SELLWOOD MORELAND IMPROVEMENT LEAGUE
8210 SE 13th AVENUE, PORTLAND, OR 97202
STATION 503-234-3570 • CHURCH 503-233-1497

April 11, 2019

The Sellwood Moreland Improvement League (SMILE) Land Use Committee has reviewed the Discussion Draft Report of the Design Overlay Zones Amendments Project (DOZA) and is providing the following comments. We focused our review on the proposed Community Design Standards because almost all new construction in our neighborhood follows those Standards. Four subcommittees reviewed the Standards item by item and we dedicated two of our monthly public meetings to discussing them and drafting these comments. We reference an attached appendix of photos to demonstrate some of our comments.

Photo 5b. A private outdoor courtyard with surrounding building on 4 sides, adjacent building above not shown and no photo possible,. Standard BM13 would provide points for a space hidden from the public. 8222 SE 6th Ave.

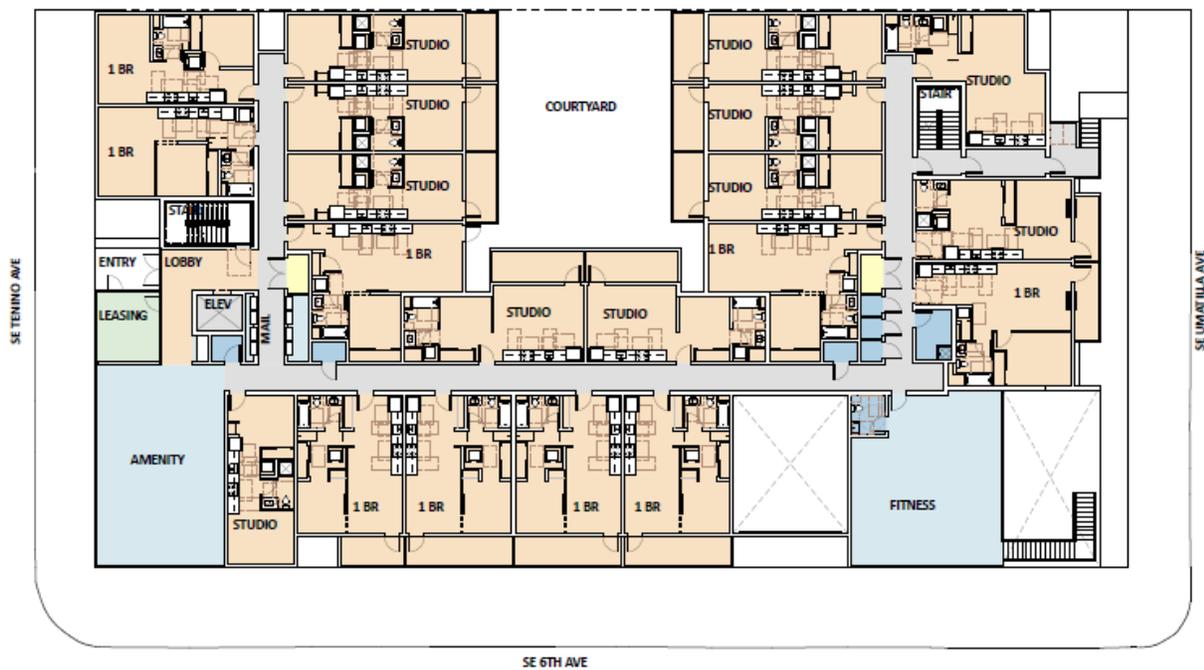
Optional Standards Points	SMILE comment
11	Building Signage at the Corner		1 pt	Support. (This standard seems to be a façade element.) Please clarify if the sign is to be within 10 feet of the corner of the building or within 10 feet of the corner of the intersecting streets.
12	Building Facades on Local Service Streets		3 pts	Clarification needed: a drawing would be helpful, what is an architectural projection? Does street right-of-way include the sidewalk? Concept is good (see Appendix photo 4).
13	Buildings Surrounding Outdoor Areas		2 pts	Modify. 1) should be for 75% or more of perimeter, not sides. 2) The outdoor area should be visible to the public (from a street). (see Appendix photos 5a and 5b)
14	Ecoroof		Recommend to reduce to 1 point 3 pts	Recommend that only 1 point be given. An eco-roof has no publicly visible improvement to the building. We like the concept of eco-roofs, but they should not be used in lieu of design features that contribute to the public realm. Does not affect building mass. Energy standards already encourage eco-roofs. (see Appendix photo 2).
